AUTOMATIC TRANSMISSION SERVICE GROUP

SEMINARS '88

TECHNICAL INFORMATION PACKAGE

Figure 2

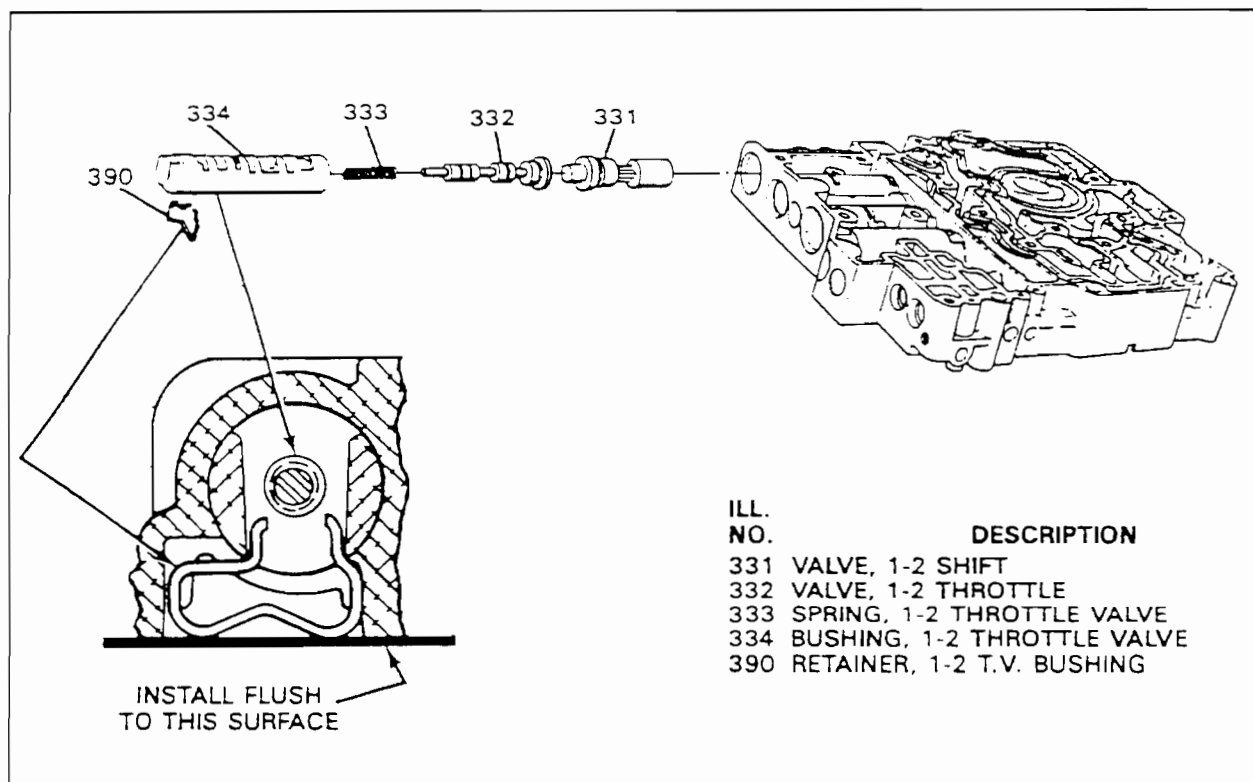
A 1984-87 vehicle equipped with a THM 440-T4 (Figure 1) may start out in 2nd gear instead of 1st gear. This condition could occur intermittently or all the time.

High line pressure could be a cause by holding too much governor pressure and not allowing the 1-2 shift valve to downshift. Check line pressure and governor pressure. Governor pressure should be below 3.0 PSI at 0 mph.

If governor pressure is okay, the 1-2 shift valve (331) may be stuck in the upshifted position. Remove the control valve assembly and check for a sticking 1-2 shift valve (331), 1-2 throttle valve (332), or the 1-2 throttle valve spring (333) caused by the 1-2 throttle valve bushing retainer (390) pushed in too far. The retainer should be installed flush with the machined surface of the valve body. (Figure 2)

DRIVEN SPROCKET BEARING SLEEVE

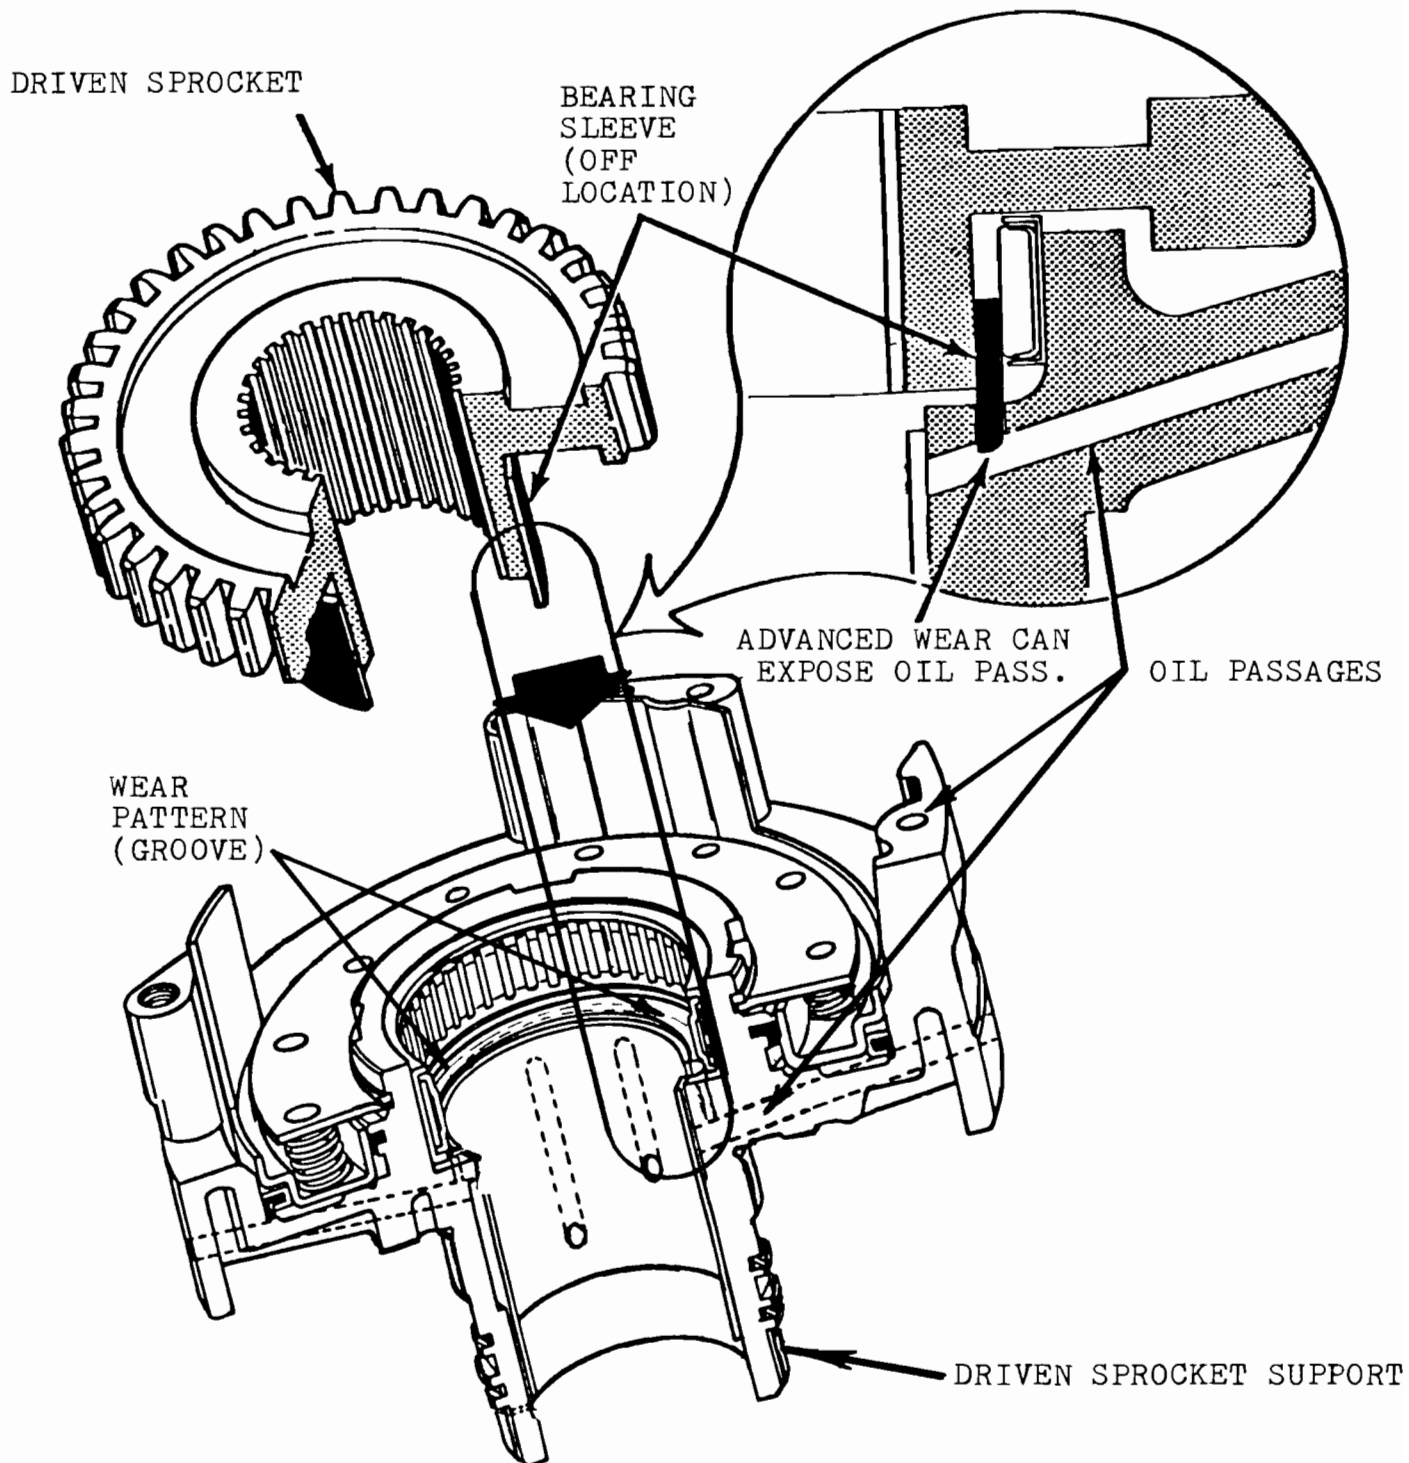
When diagnosing a THM 440-T4 transaxle for slipping shifts, or erratic shifts, check the driven sprocket support for wear as shown in illustration.

This wear pattern, if present, is caused by the bearing sleeve on the outside hub of the driven sprocket moving and wearing into the driven sprocket support. As this wear condition reaches an advanced state the oil feed passages in the driven sprocket support could be exposed, allowing an oil pressure cross leak.

The bearing sleeve on the driven sprocket may, after causing the described wear pattern (Groove), move back on to the driven sprocket and appear to be normal. If this condition is suspected, be certain to check the driven sprocket support for the wear pattern as shown in illustration.

If the above condition exists, replace the driven sprocket, driven sprocket support and any other affected parts. Be certain to check all four clutch packs in the transaxle as they are all fed through oil passages in the driven sprocket support. Repair or replace as necessary.

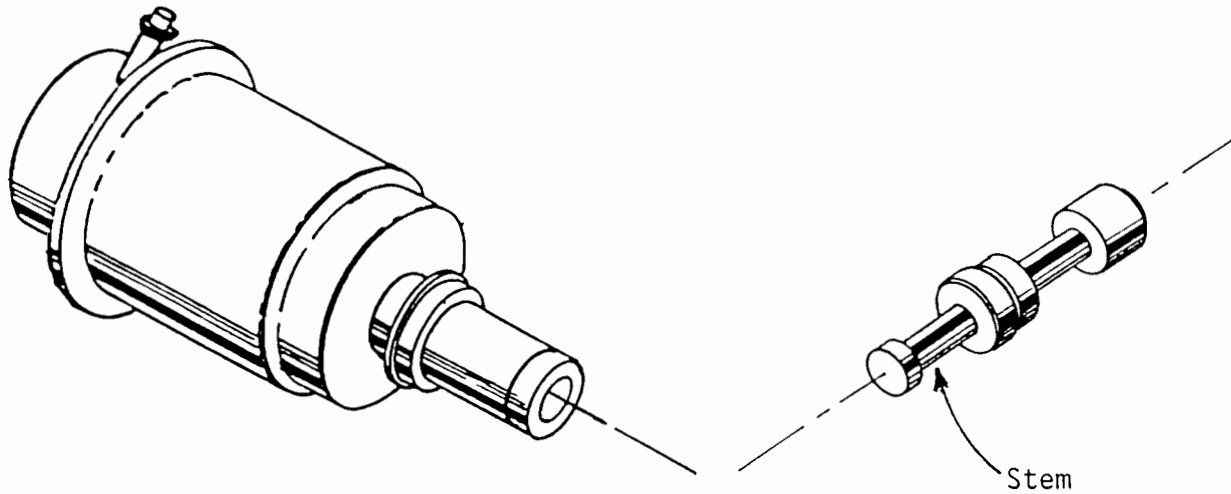
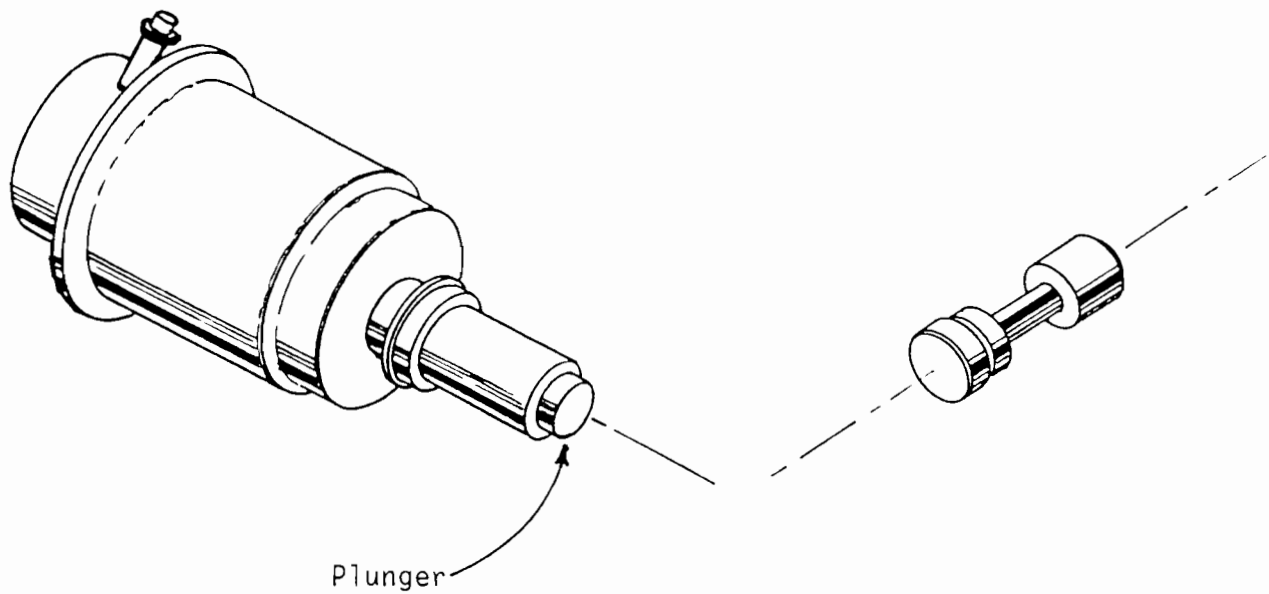
Some THM 440-T4 transaxle models may exhibit harsh upshifts when operated at high altitudes. This condition may be caused by excessive line pressure resulting from insufficient engine vacuum.

Refer to Figure 1 for the previous vacuum modulator and modulator valve, and Figure 2 for the latest vacuum modulator and modulator valve.

Figure 25

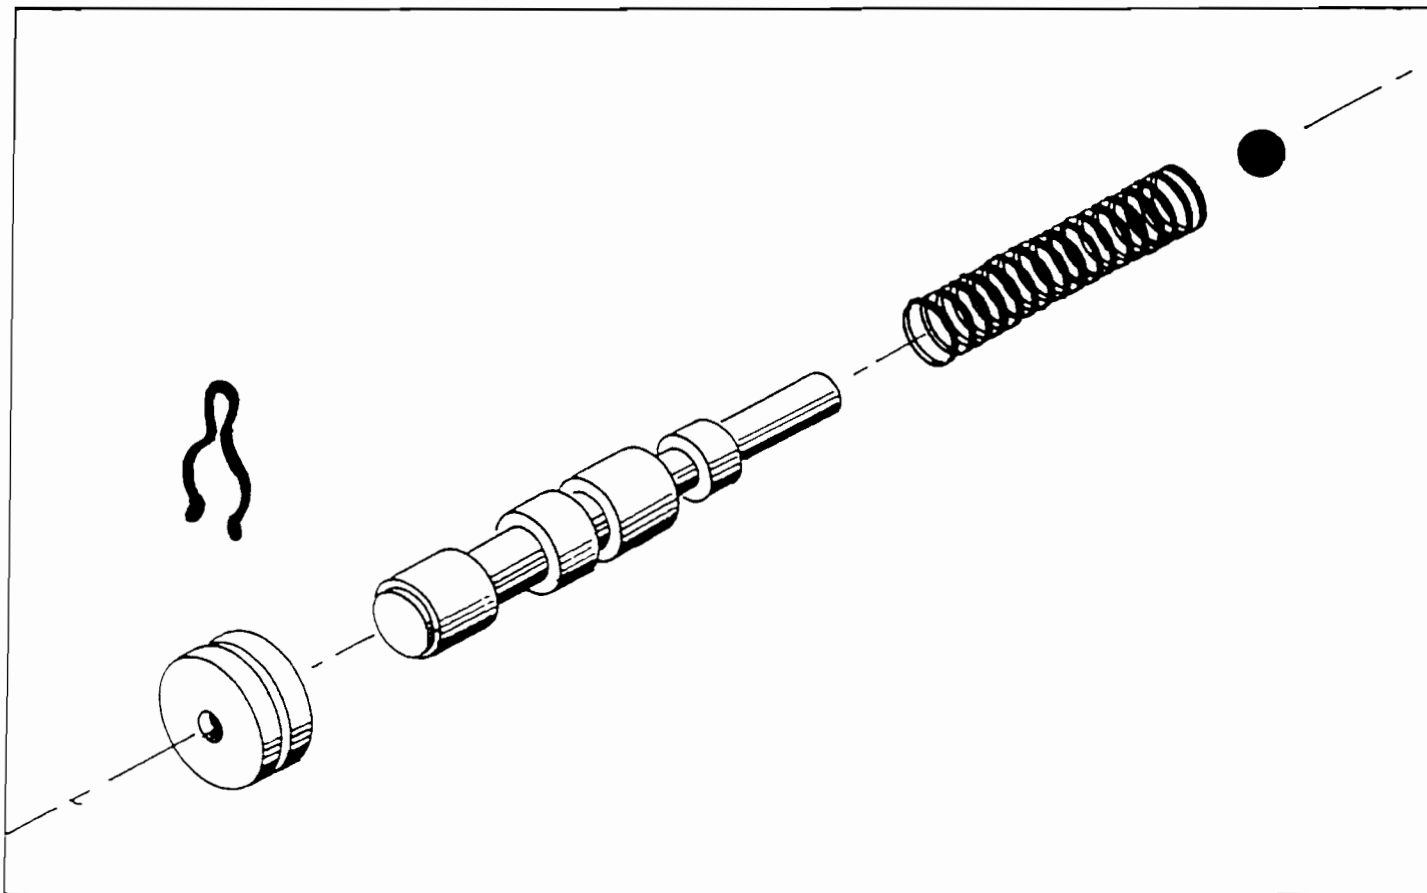
One caution, about half of the many different 440-T4 models do not use a spring behind the TCC regulator valve. If you encounter one of these, you will also have to install the spring, so that the check ball will stay centered in the bore (See Figure 25)

Install a C-4 Viton check ball, behind the TCC regulator valve in the valve body (See Figure 25). This will raise converter apply pressure Approx. 20 PSI, and provide a positive application of the converter clutch.

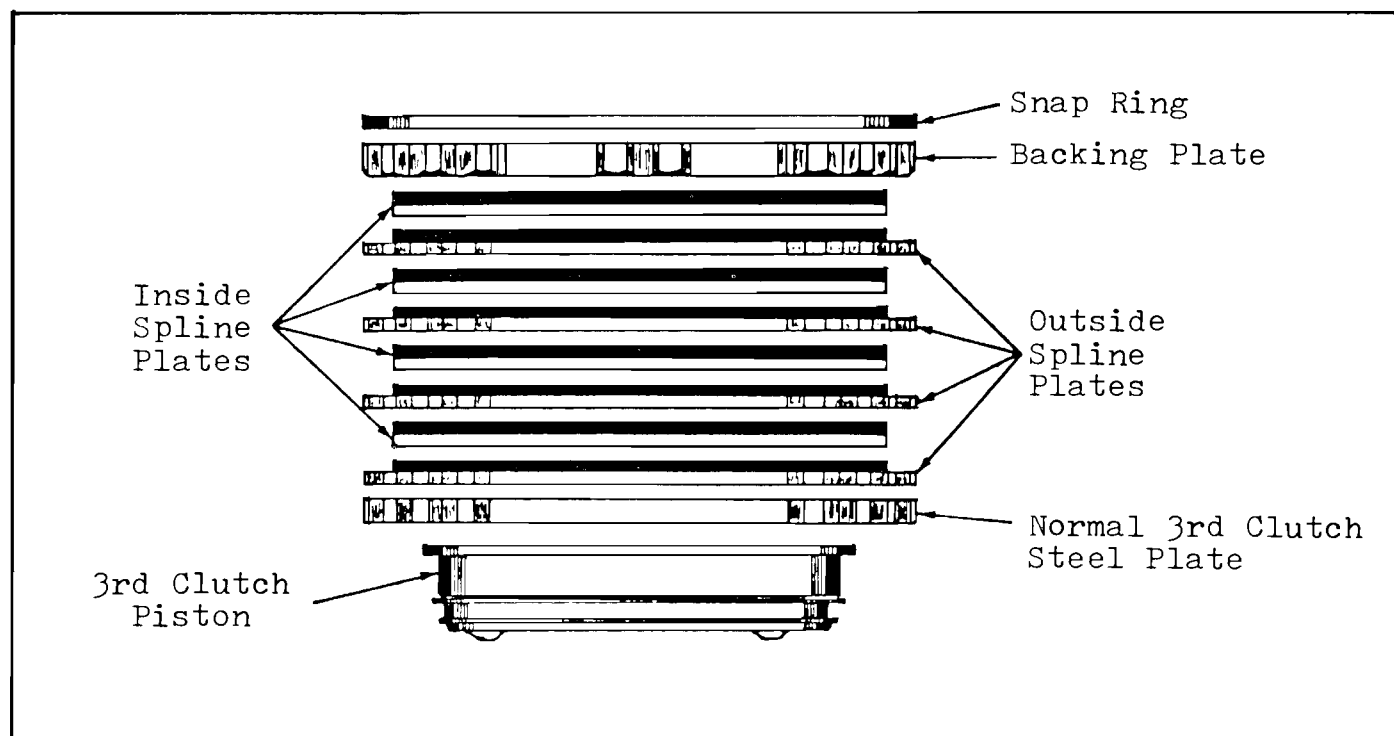
The single sided 3rd clutch plates will retro fit backwards and are recommended, as long as proper assembly procedures are used. The proper assembly procedures for the 3rd clutch pack on models 5CP, 5CM, and all 1986 up 440-T4 transaxles is shown in the figure below.

The 3rd clutch pack on the models mentioned above have single sided clutch plates, or clutch plates with lining on one side only. Notice that the outside spline plates, or what we normally refer to as "Steel" plates, also have lining on one side only. Notice also that the clutch pack is started with a normal 3rd clutch steel plate, and is followed with an outside spline plate with the "Lining UP". Steel against steel will not be a problem as long as they are both outside spline plates, because they cannot counter rotate against one another. Obviously if you followed the normal steel plate with an inside spline plate you would have steel counter rotating against steel, and damage to the clutch pack would result.

They must be assembled as shown, and you must start with a normal 3rd clutch steel plate to obtain proper clutch clearance.

Figure 3

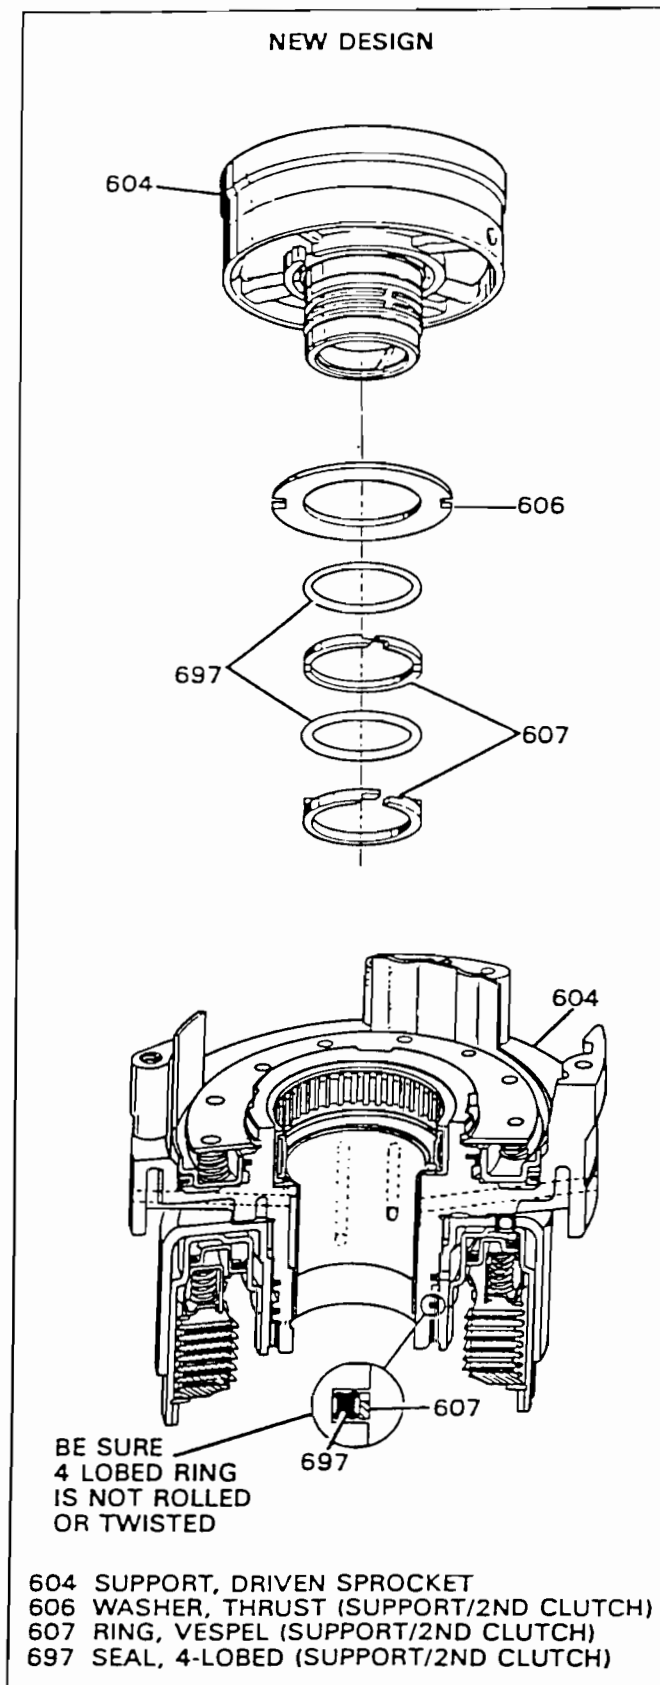
Due to changes in the driven sprocket support for 1987, the new Vespel (TM) oil seal rings and 4-lobe ring seals are not interchangeable with the cast iron oil seal rings on models built prior to 1987 Start Of Production (SOP). Changes made to the driven sprocket support include deeper seal ring grooves and "cutouts" to accommodate the ring tangs which prevent the Vespel (TM) oil seal rings from rotating (refer to Figure 3).

Figure 1

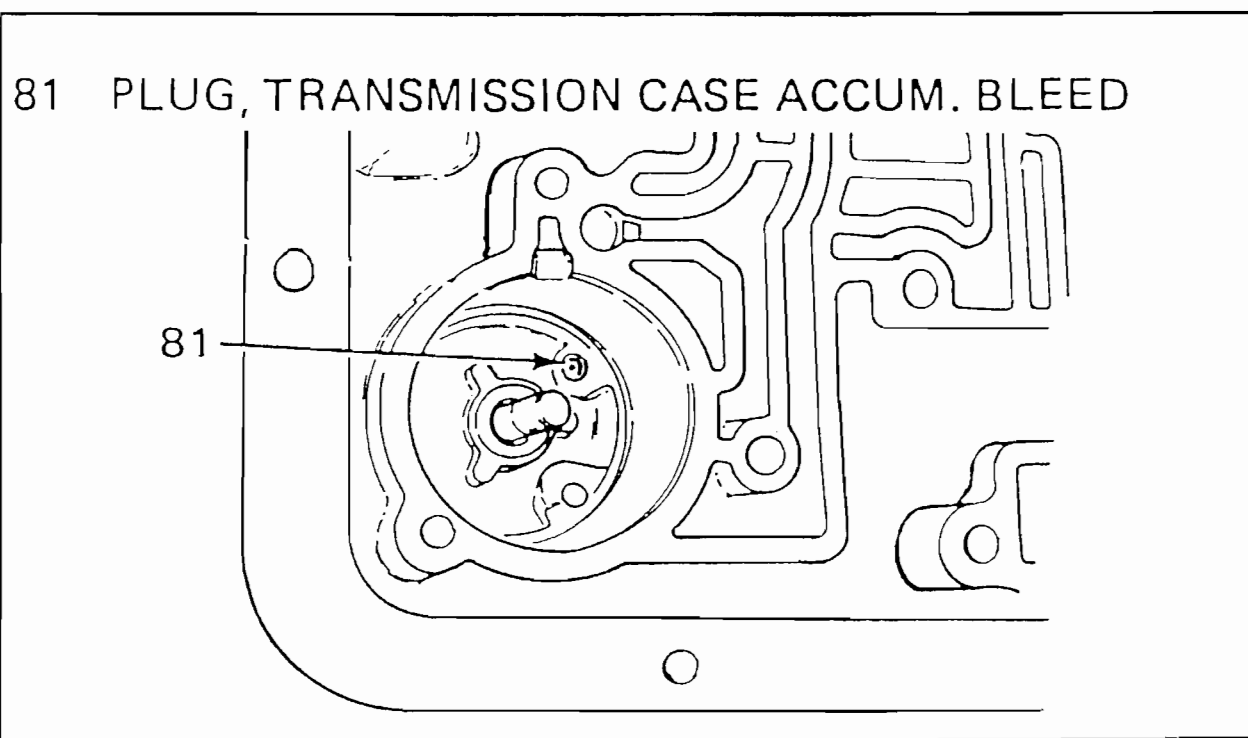
- COMPLAINT: No 4th gear; 2nd and 4th pressure lower than line pressure.
- CAUSE: The cause could be the bleed orifice cup plug missing from the case in the bottom of the 3-4 accumulator bore (see Figure 1).
- CORRECTION: Install bleed orifice cup plug, OEM Part Number 8628864.
